**Project #19-026
University Village Pad A
Located at 1400 N 600 E**

Project Name: University Village Pad A
Proponent / Owner: Melanie Child / Auburn Manor Holding Company
Project Address: 1400 N 600 E
Request: Design Review Permit
Current Zoning: Commercial (COM)
Type of Action: Quasi-Judicial
Hearing Date: August 8, 2019
Submitted By: Aaron Smith, Planner II

Staff recommends that the Planning Commission **conditionally approve** a Design Review Permit for Project #19-026, University Village Pad A, for one 5,620 SF commercial building at approximately 1400 N 600 E, TIN #04-086-0017.

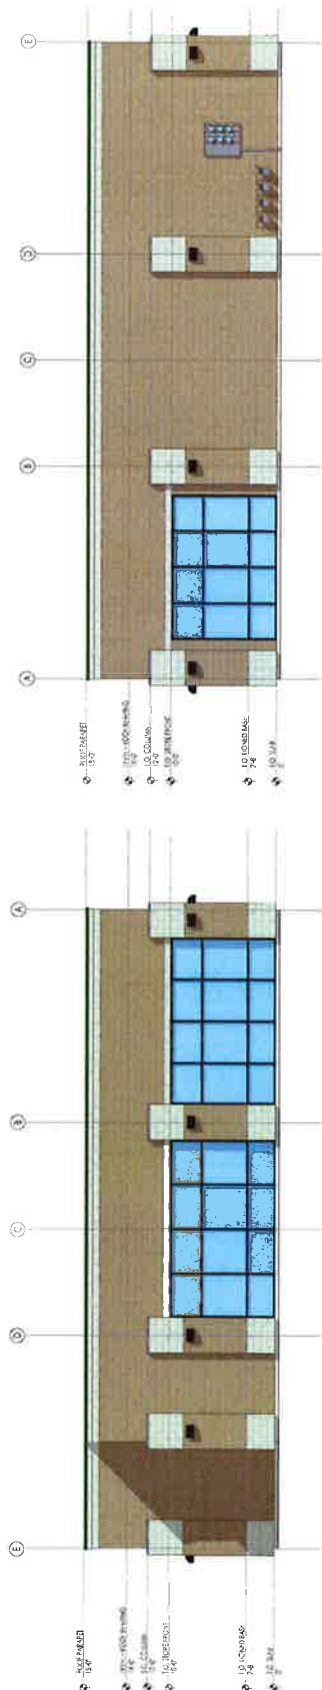
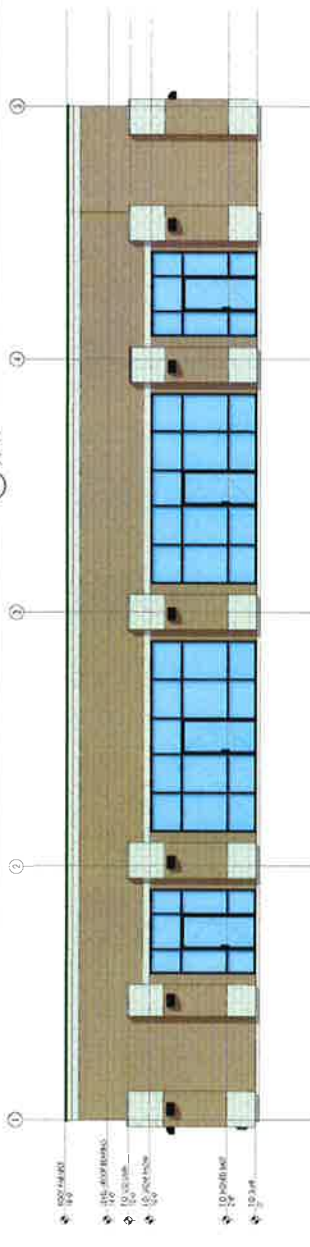
Pedestrian entrances are required to have weather protection. The proposed building design does not include weather protection above pedestrian entrances. As conditioned, with weather protection above pedestrian entrances, the project complies with the requirements in the LDC.

The buildings have clear horizontal articulation with changes in color, material, and projections that divide up the building's facades. Varied roof or parapet forms are required to break up the scale of the building. As conditioned, the project complies with the requirements in the LDC.

South Elevation (1400 W Frontage):	39%
North Elevation (Towards Parking):	54%
East Elevation (600 W Exposed side):	38%
West Elevation:	14%

1. All standard conditions of approval will be recorded with the Design Review and are available in the Community Development Department.
2. A bike rack shall be installed.
3. Pedestrian entrances shall have overhead weather protection.
4. The parapet form shall be designed to provide variation.

CONCEPTUAL PLAN

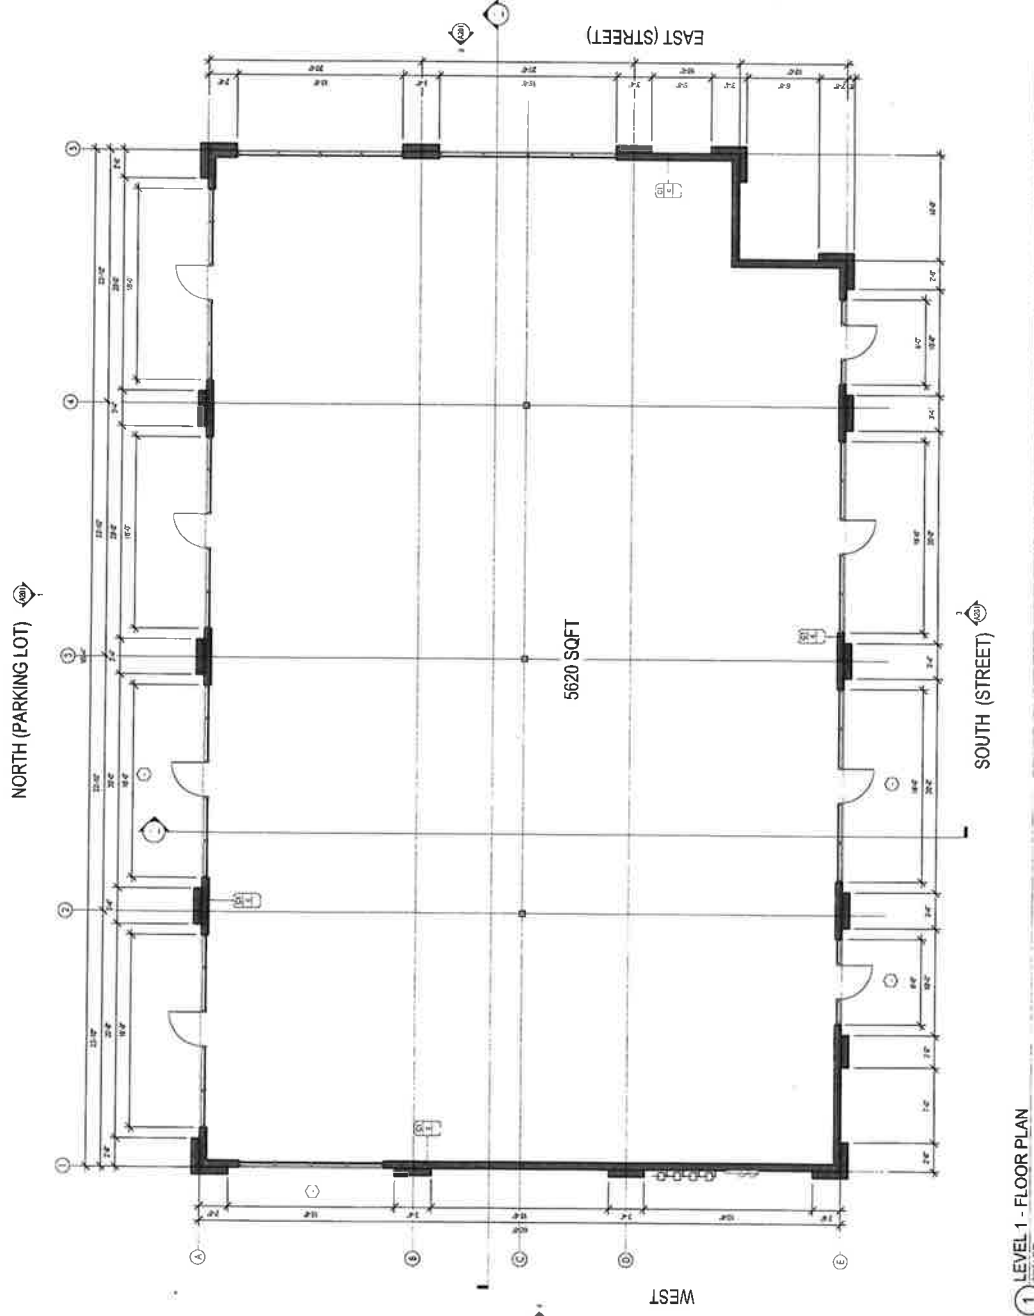
Existing vehicular driveway access is located on 1400 N and 600 E. The access along 1400 N is proposed to be redesigned and the drive/turn into the project site extended further to the north. This extension removes several existing parking stalls and moves the landscaped parking isle endcap further north. The change to the 1400 N access will reduce congestion near the ingress/egress point to the development and improve site circulation overall. No changes are proposed to the 600 E access. The project proposes a pedestrian access point from the commercial building to 1400 N. This pedestrian access will help to connect the new building to the primary 1400 N corridor. As proposed, the project complies with the requirements in the LDC.

For the commercial building, including banks, the LDC 17.31 requires one (1) parking stall per 250 SF. If a portion of the commercial space developed as fast-food restaurant space, parking would be required at 1 per 150 SF. The 5,620 SF commercial building would require between 22-30 parking stalls based on use. As the site plan proposes the elimination of existing parking stalls and shares parking with adjacent uses, the overall parking need that was permitted with the original development has been considered while calculating parking. The existing grocery store, retail spaces, and restaurants were permitted with 327 required parking stalls. With an additional 30 parking stalls required for the new building, 357 parking stalls must be provided over the entire University Village site. There are currently 453 stalls over the entire site. With the elimination of 23 parking stalls by the placement of new building, 430 parking stalls will remain on the site. The majority of the existing stalls are accessible to the new development, and the remaining stalls are sufficient to ensure parking for adjacent uses. The LDC requires bike racks in commercial zones. As conditioned, with bike racks, the project complies with the requirement of the LDC.

The drive-through lane is required to have a minimum of 3 stacking positions for a bank teller or 8 stacking positions for a restaurant. The proposed drive-through lane provides 14 stacking positions. As proposed, the project complies with the requirements in the LDC.

5. A performance landscaping plan, prepared in accordance with §17.32 of the LDC, shall be submitted for approval to the Community Development Department prior to the issuance of the building permit. The plan shall include the following:

- a) A minimum of 3,900 SF of both open space and usable outdoor space, for a total of 7,800 SF, shall be provided
 - b) A total of 18 trees and 45 shrubs, flowers and ornamental plants shall be provided.

- c) Interior parking lot landscaping areas are required to have a minimum of 2 trees and a 50% plant material coverage at plant maturity.
6. Exterior lighting shall be concealed source, down-cast and reviewed and approved prior to the issuance of a building permit and shall comply with current LDC regulations.
